# Memo

Re: 6400 American Boulevard – Detailed Site Plan (DSP-21006) Discussion

The purpose of this memorandum is to provide the City Council with recommendations related to the detailed site plan (DSP) application for 6400 American Boulevard.

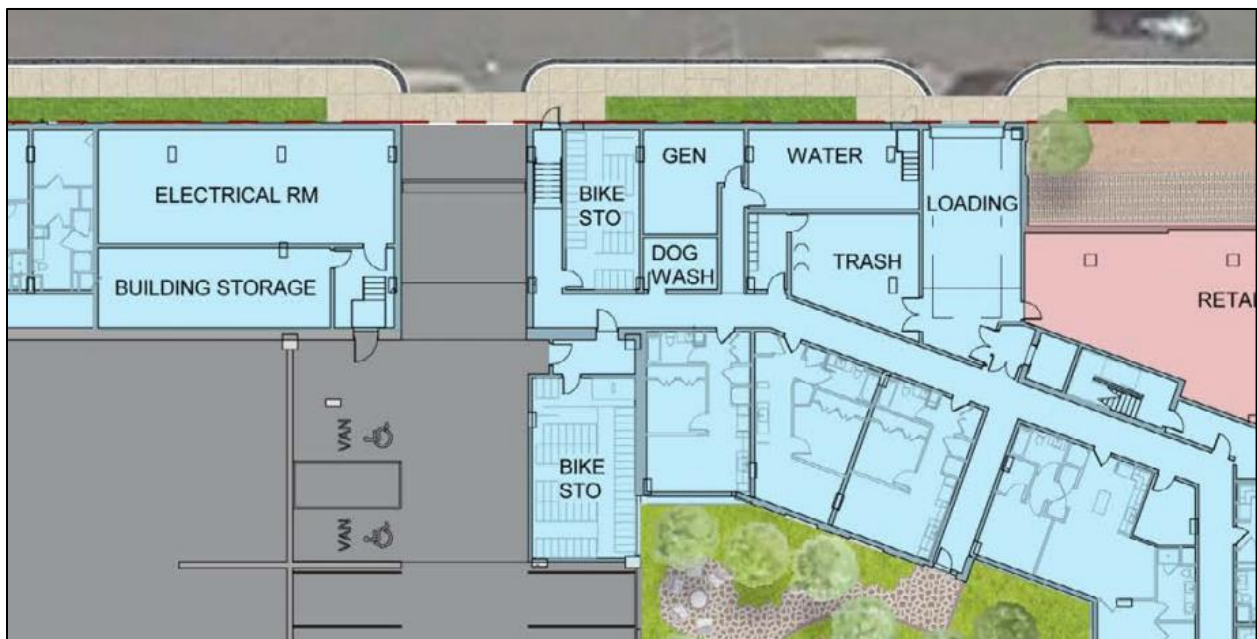
To remain aligned with the policies outlined in the Prince George’s Plaza TDDP, Staff recommends any part of the structured parking garage visible to pedestrians include screening either through the use of architectural treatments, public art, or landscaping. This will make the development more pedestrian friendly and add visual interest. Staff also recommends the applicant consider installing renewable energy systems or green roof elements on the garage roof as outlined in Chapter 6 of the TDDP.

Additionally, staff recommends the inclusion of parking spaces accompanied by EV charging stations within the structured parking garage.

The building’s south elevation, as seen from East-West Highway, is depicted in the image below.

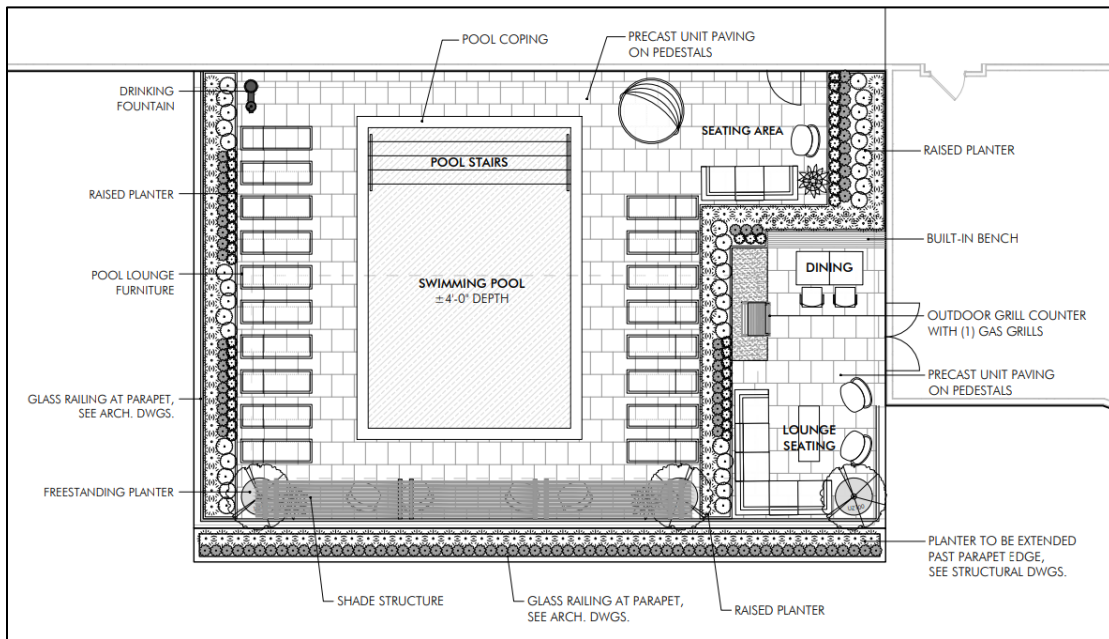
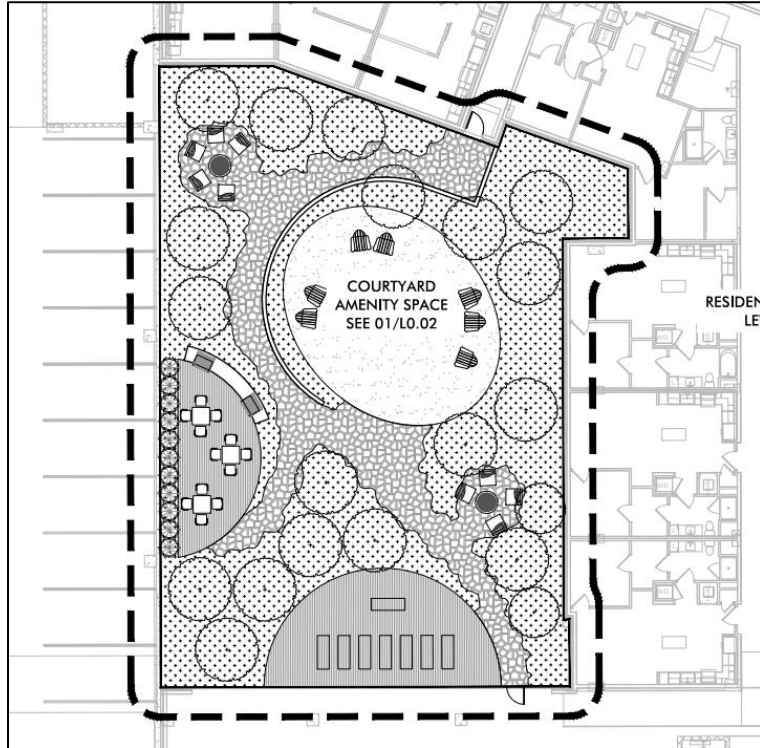
Staff recommends further attention be paid to the architectural design along East-West Highway. Located in the Downtown Core, there is an opportunity to establish a sense of identity and contribute to the visual and architectural character of the area.

Located within short walking distance of the Prince George’s Plaza metro station, this is an area of high pedestrian and bicycle traffic. The massing and articulation of the building should reflect this.

The building design should focus more on the pedestrian experience rather than the vehicular experience. Further irregularities in the design of the façade, specifically on the ground floor, can break up the massing/volume of the building.

Additionally, the use of public art along the East-West Highway façade can enhance the pedestrian experience and create a sense of place.
